24 November 2008

Request for review – "Jinan Landfill Gas to Energy Project" (0933)

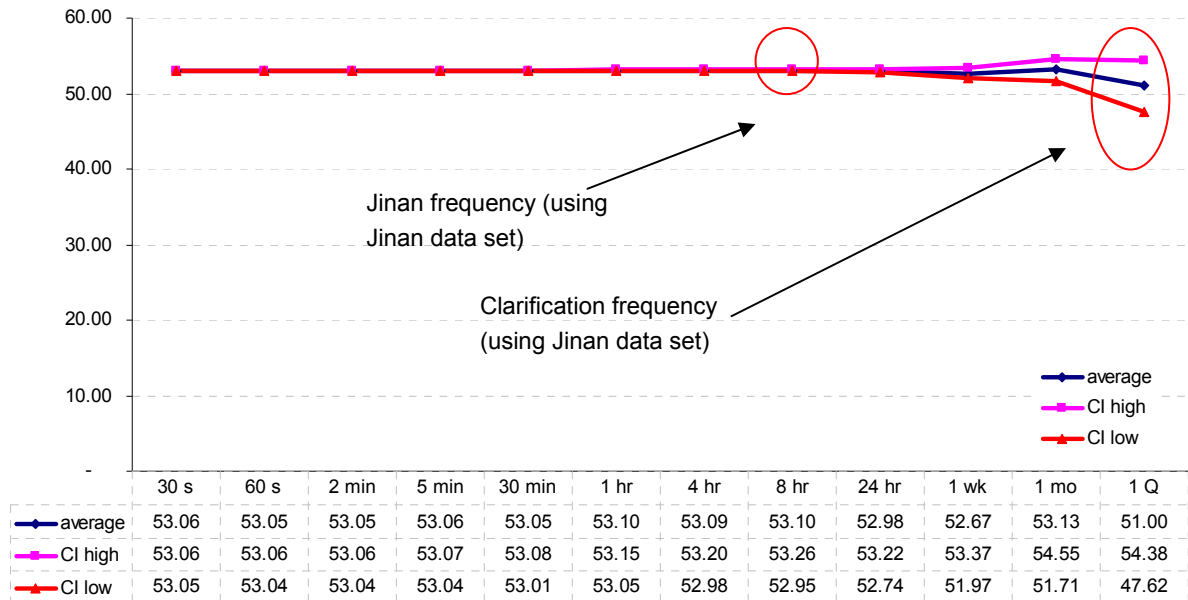
1. The DOE is requested to clarify how it verified that the clarification by the meth panel (AM_CLA_0095) on the application of lower bound of 95% confidence interval had been followed, since the monitoring of methane fraction in LFG was not conducted continuously [1]

The analysis above shows that the sampling on this project provides an adequate sample size (i.e. it could be considered continuous). When the methane results are subject to the calculations as per ACM0001 version 9.1, no material impact is seen on the emission reduction.

This outcome is best explained by the central limit theorem. This defines that the distribution of all sample means (or proportions) is normal, as long as the sample size is large enough [3] and the averages of the methane concentrations for different simulated methane sampling regimes of the Jinan landfill in the graph [shown below] further emphasizes this point. The graph is produced by using the dataset of methane measurements and a statistical tool (XLSim) to make a statistical simulation, with higher frequencies are simulated by a Monte Carlo statistical analysis [4].

As can be seen only the uncertainty increases; the averages are the same [53%] up to a 1 month sampling frequency. The frequency distribution of methane and the sampling frequency is such that the uncertainty (95% confidence interval bandwidth) increases only marginally up to a 24 hour sampling frequency.

The sampling frequency used in Jinan results in a 0.2% confidence interval range around the mean. In view of the central limit theorem, the absence of any quantitative limits on uncertainty levels and the size of the uncertainty observed, it is derived that a 0.2% confidence interval range has no material effect on the calculation of the emission reductions.
